Intel[®] Pentium[®] III Xeon[™] Processor Specification Update

Release Date: May 2000

Order Number: 244460-014

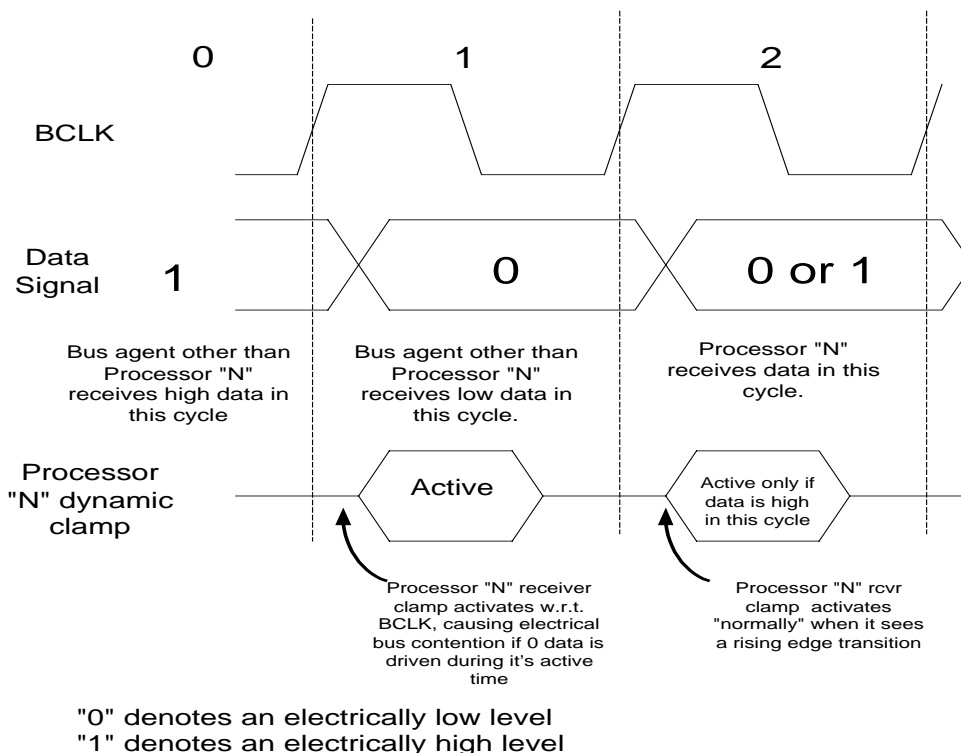
Workaround: The AGTL+ V_{REF} (input voltage reference) level will be raised from 1.0V to 1.1V (assuming a V_{TT} of 1.5V) on the processor cartridge substrate. This allows the dynamic clamp to activate at a trigger level approximately 100 mV higher than with the previous 1.0V V_{REF} setting. Due to the dependence upon system bus design, bus layout may be evaluated to determine the need for improvements in falling edge ringback levels. This may involve one or several of the following baseboard modifications:

1. Change termination resistor value to reduce multi-bit noise and/or improve V_{IL} noise margin.
2. Reduce multi-bit noise by improving ground return paths (additional high-frequency decoupling, improved AC plane referencing, etc.).
3. Raising or lowering the V_{TT} level (within the AC & DC tolerances specified in the processor EMTS) to improve V_{IL} noise margin and/or reduce the multi-bit noise due to di/dt transients.

Stress tests using various data patterns and transactions should be run to identify the worst-case multi-bit noise conditions for this erratum.
